Company	Trenz Electronic GmbH
PCN Number	PCN-20180511
Title	PCN-20180511 TE0841-01 to TE0841-02 Hardware Revision Upgrade
Subject	Hardware revision 01 to 02
Issue Date	20180511

This change affects all Trenz Electronic TE0841 SoMs: TE0841-01*.

Affected Product	Replacement
TE0841-01*	TE0841-02*

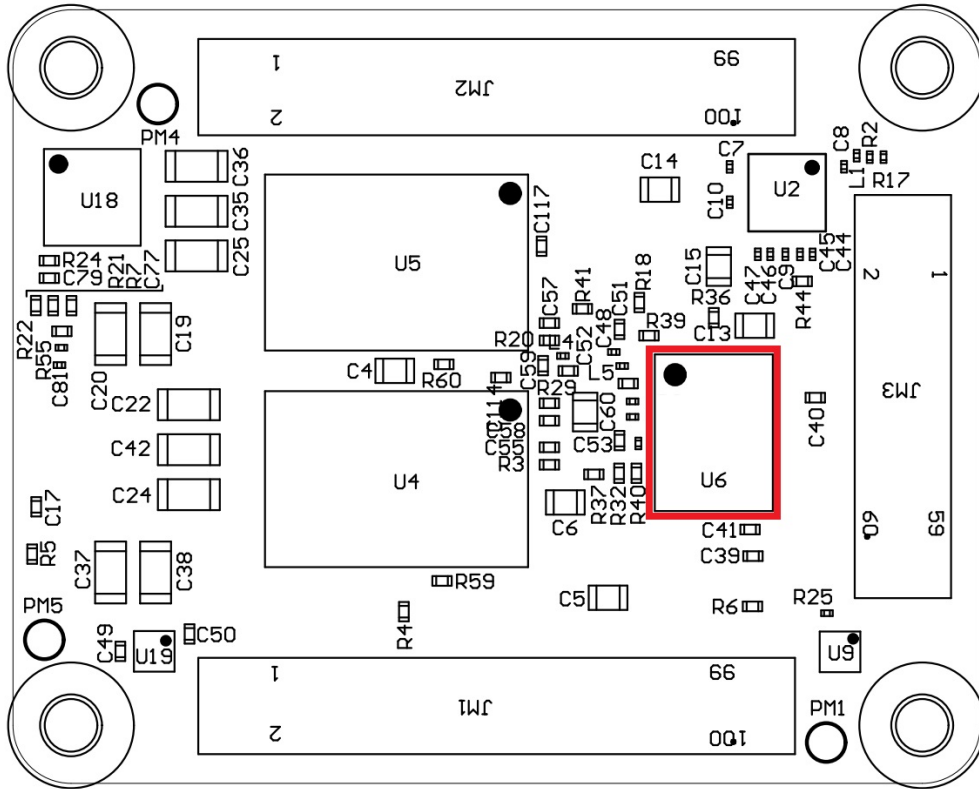
## #1 Change SPI Flash from N25Q256A11E1240E to N25Q512A11G1240E

Type: BOM change

Reason: N25Q256A11E1240E became obsolete, replacement part not available for purchase. This is only interim solution because N25Q512A11G1240E is also obsolete already. It will be changed after the replacement parts get available.

Impact: Size changed from 256 MBit to 512 MBit per chip. JEDEC ID changed from BB19h to BB20h both with manufacturer ID: 20h.
